# Hybrid Power Determination

Comment from JAPAN

Hybrid system power  
 $TP1 = R1 + R2$

7.Oct.2019

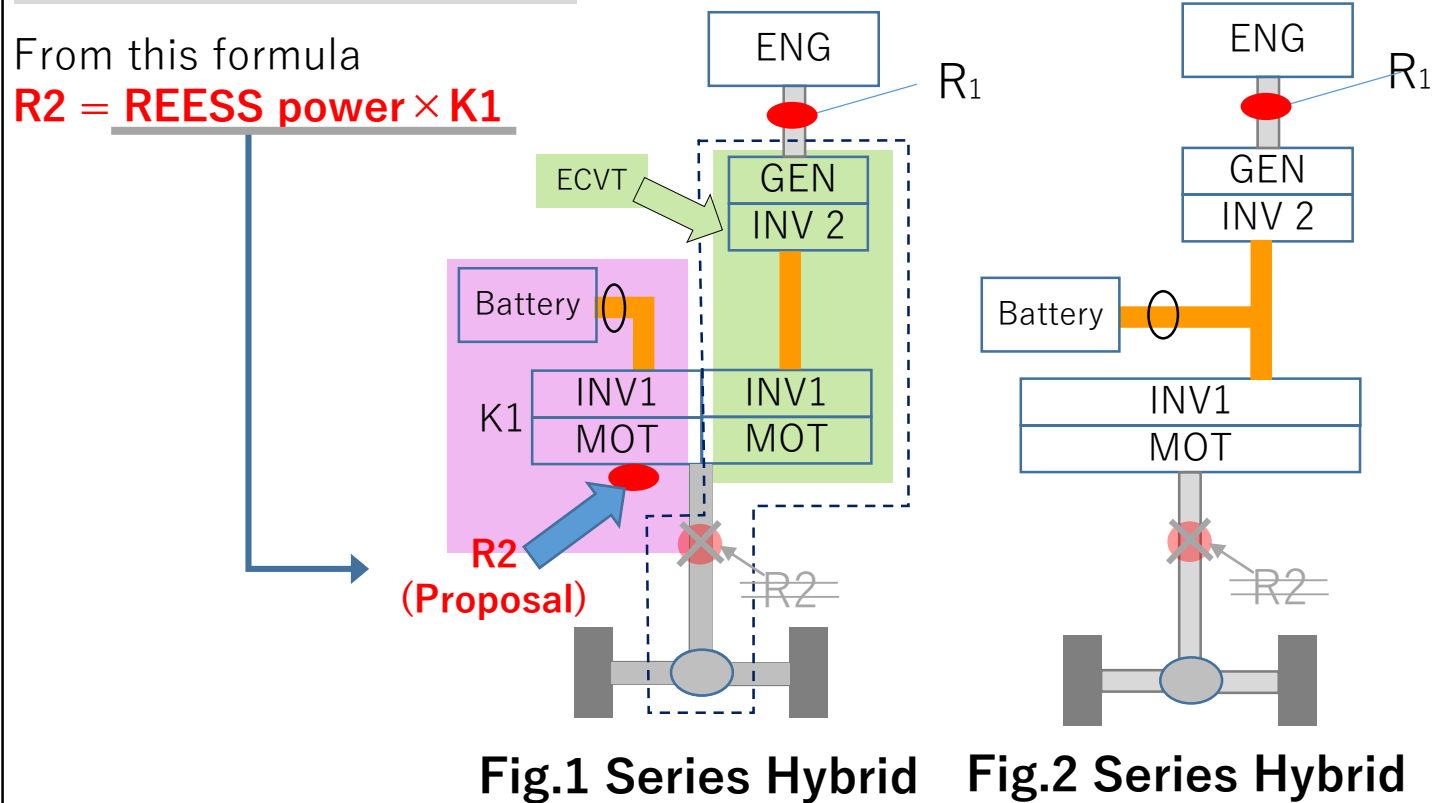
Fig1 is same meaning of Fig2.

R1 is ICE originated power and R2 is REESS originated power. Double-counting issue does not occur even if summing up R1 and R2. (Fig1)

R2 is defined as the battery originated power, it is sufficient to measure the battery power.

GEN/INV2 is downstream of R1. Measurement of GEN/INV2 power is not necessary for TP1. And losses of GEN/INV2 does not include for TP1.(Fig1)

Fig.1

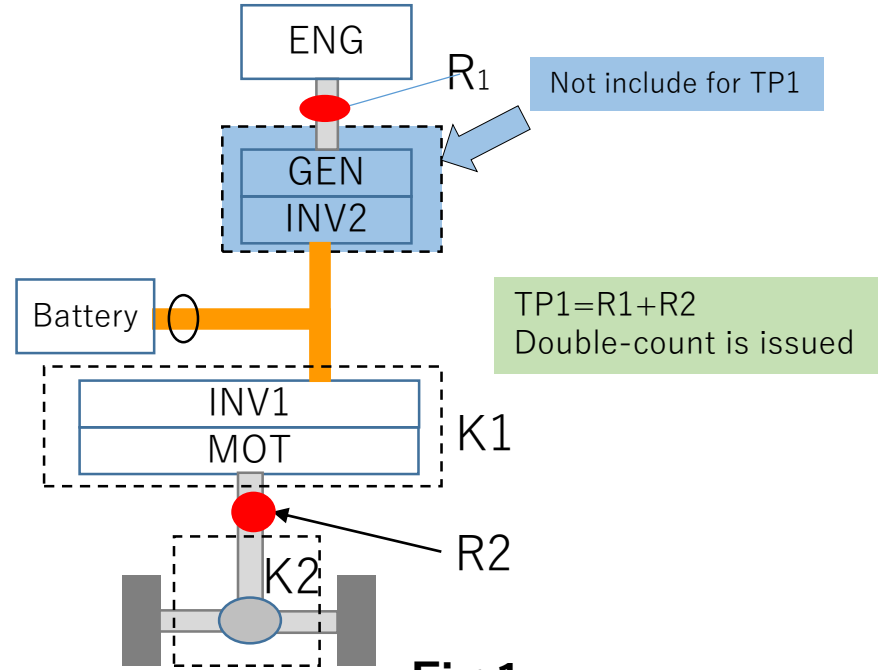
For series or mixed (power split) hybrids, **TP1 will always give a higher result** than TP2 because TP1 **does not account for electrical conversion losses** in the series portion.

Losses in the electrical conversion path (G + Inv2) would not be accounted for.

**TP1 > TP2 is occurred**

Fig.2

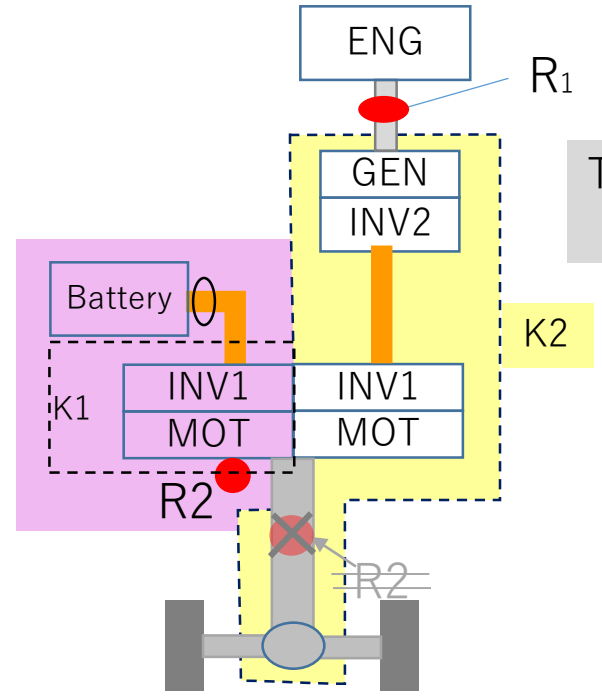
**R2 is part of motor output, which REESS originated power only.**  
**Double-count of engine power does not occur, because R2 does not include engine originated power.**

**TP1 does not show a higher value than TP2.**
